Title - Sujet Fuel Tank and Components	
Solicitation No. - N° de l'invitation W3557-120024/B	Amendment No. - N° modif. 005
Client Reference No. - N° de référence du client W3557-120024	Date 2012-04-24
GETS Reference No. - N° de référence de SEAG PW-\$MCT-014-4434	
File No. - N° de dossier MCT-1-34452 (014)	CCC No./N° CCC - FMS No./N° VME
Solicitation Closes - L'invitation prend fin at - à 02:00 PM on - le 2012-05-07	Time Zone Fuseau horaire Atlantic Daylight Saving Time ADT
F.O.B. - F.A.B. Plant-Usine: <input type="checkbox"/> Destination: <input checked="" type="checkbox"/> Other-Autre: <input type="checkbox"/>	
Address Enquiries to: - Adresser toutes questions à: MacDonald, Charline	Buyer Id - Id de l'acheteur mct014
Telephone No. - N° de téléphone (506) 851-6067 ()	FAX No. - N° de FAX (506) 851-6759
Destination - of Goods, Services, and Construction: Destination - des biens, services et construction:

Title: Fuel Tank and Components

Solicitation Amendment No. 005

ANNEX(E) "C"

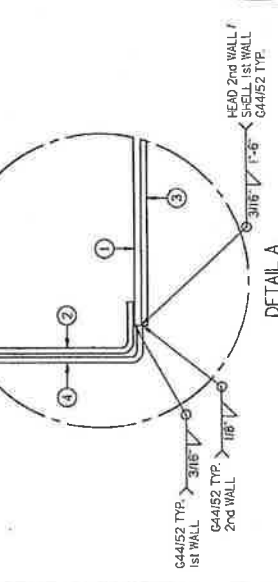
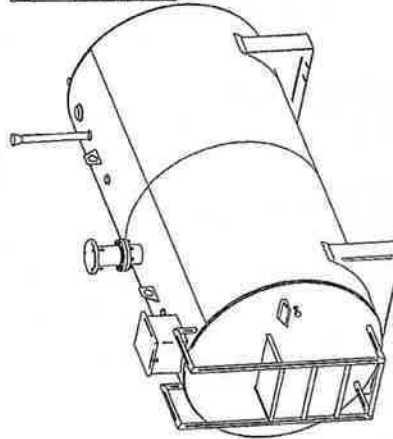
Q6. I am inquiring about solicitation No. W3557-120024/B – Fuel Tank and Components with regards to the stairs and platform. I was wondering if a ladder and platform system would be sufficient as the company I am speaking to states a ladder and platform system is more appropriate and safety oriented due to the style and height of the tank. I have attached a drawing at ANNEX “C” of the tank for reference. Would this type of ladder and platform system be acceptable?

A6. No, a stair is required, not a ladder and it must adhere to safety regulations. Please refer to attached ANNEX “D”, however a hand rail might be required.
